## Planning Commission Vote Report

**Subject:** Change of Zoning Vote Report

**Petition:** **P.Z. 02-2015 Falling Leaves Estates II (1925 & 1921 Wilson Ave)**

**Figure 4 – Common Ground & Common Open Space**

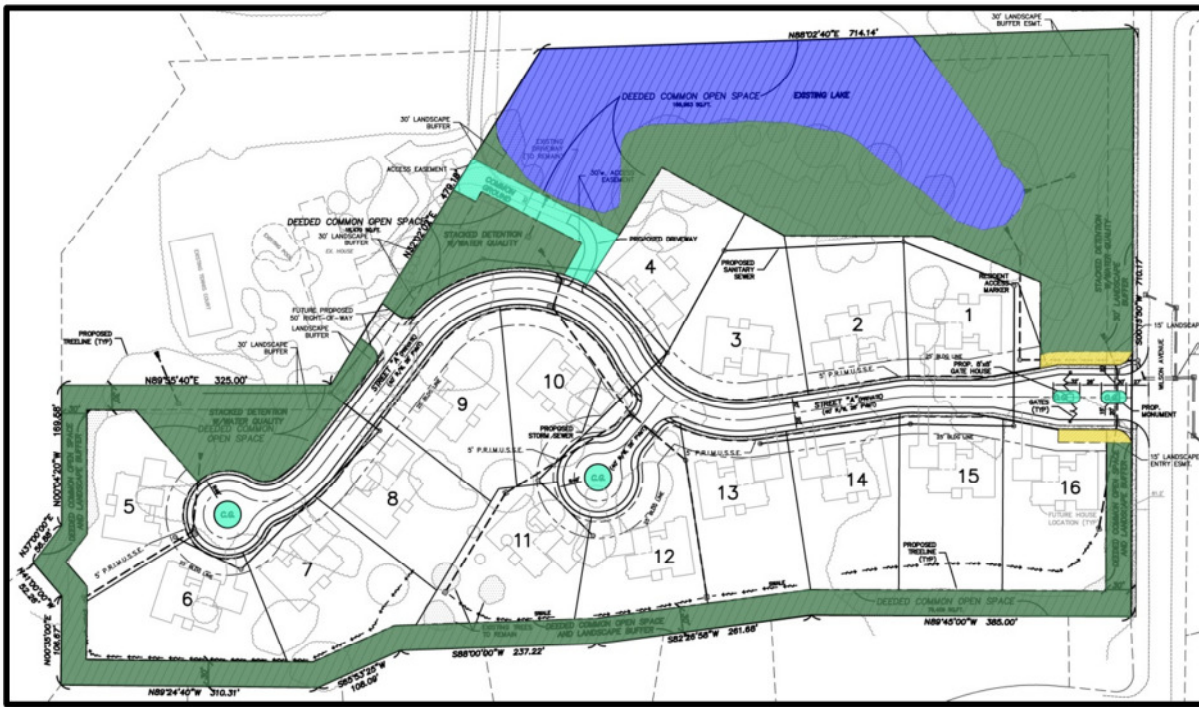
To address the Planning Commission concern about the proximity of Lot 16 to the entrance gate, the Petitioner will provide an additional 15 foot Landscape Easement, located on each side of the private entrance. This area will contain landscaping and will provide a buffer, especially

for Lot 16, from the gated entrance. The exact location and type of landscaping will be determined during Site Development Plan review, if this zoning map amendment request is approved. (This easement area is highlighted in yellow on Figure 4 below).

- As discussed above, the Petitioner redesigned the Preliminary Plan to remove the lot proposed near the northeast corner of the site. This, in turn with the combination of proposed density, would allow for 38% of the site (6.52 acres) being reserved as Common Open Space – this includes the existing lake on the site. The previous Preliminary Plan only had 34% Common Open Space.

An additional 0.23 acres (1%) of Common Ground is proposed and is located near the lake, near the entrance, as well as landscape islands within cul-de-sacs. Figure 4, below, highlights the areas dedicated as Common Open Space (darker green and blue for the lake) and Common Ground (lighter green).

**Falling Leaves Estates II**  
 CHESTERFIELD, MISSOURI  
 Preliminary Development Plan

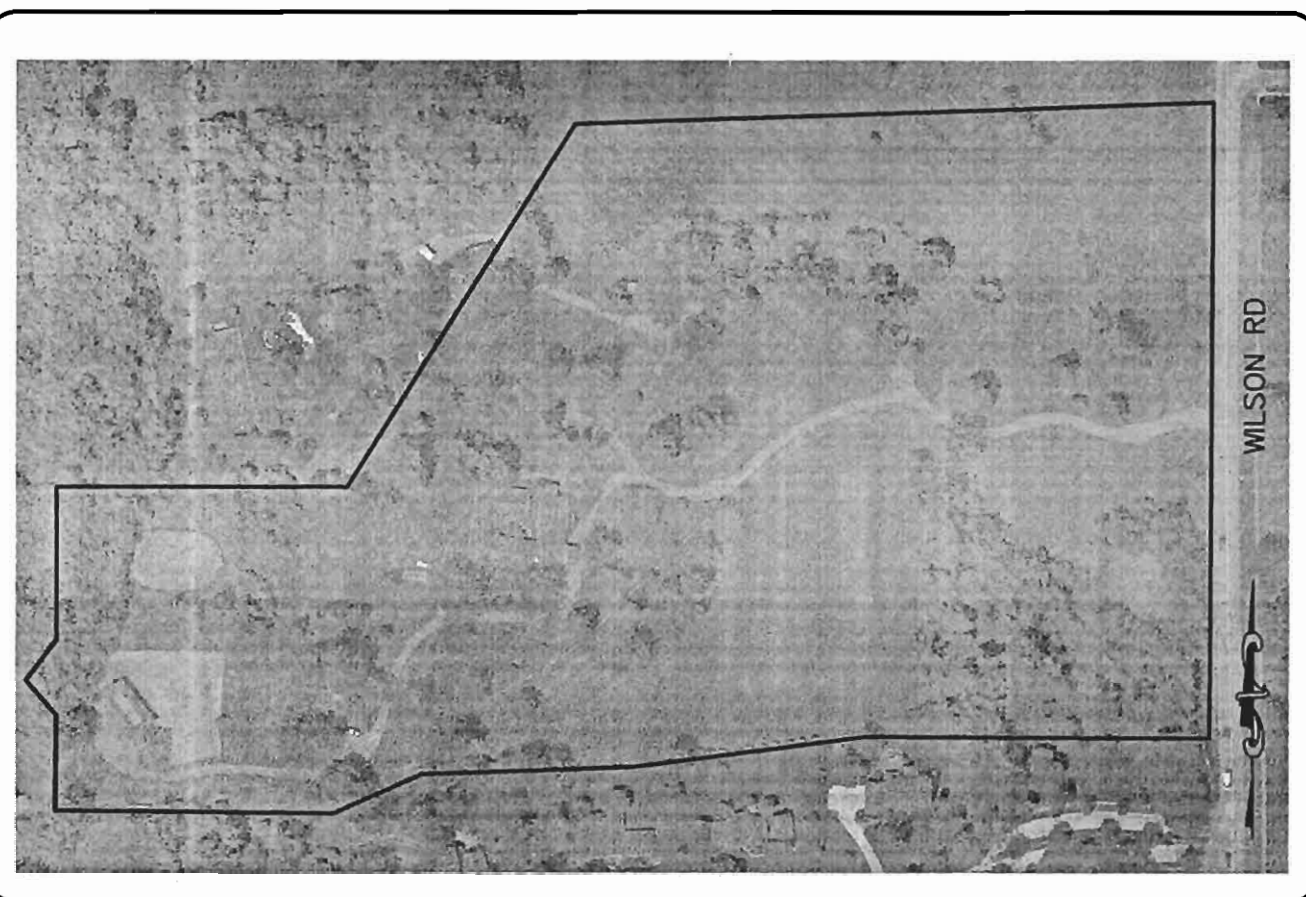
As discussed at the April 13<sup>th</sup>, 2015 Planning Commission meeting, there were some discrepancies in the front yard setbacks. Some areas showed a 20 foot front yard setback and some areas showed a 25 foot front yard setback. The Petitioner has cleared up this inconsistency and is proposing a 25 foot front yard setback for all the lots.

- During the Public Hearing, there were concerns raised regarding the number of curb cuts along Wilson Avenue. The Preliminary Plan presented during the Public Hearing was for 17 lots, which included a single lot near the northeastern corner of the development. As discussed previously in this report, the Petitioner has amended the request and Preliminary Plan and is now proposing only 16 lots on the 17.37 acres. All the lots will be accessed via a private, gated entrance off of Wilson Avenue. There will be no additional curb cuts along Wilson Avenue. And as seen during the Public Hearing, the existing private drive used to currently access the subject site will be relocated further south along Wilson Avenue.

- There were some concerns raised at the Public Hearing regarding the additional stormwater this development would create and how it would be handled. The development will contain 3 stacked detention basins to handle all the stormwater on the site. Furthermore, all of the City of Chesterfield and the Metropolitan Sewer District (MSD) stormwater requirements will have to be met and will be evaluated in detail during the Site Development Plan review, if this change of zoning request is approved.

Furthermore, there were questions asked about the future of the small pond near the southeastern corner of the development (on what is proposed as Lot 16 in the new plan). The existing pond on the proposed Lot 16 will be drained and eliminated per the Petitioner’s response. This pond will be filled and graded to match adjacent grades on proposed Lot 16.
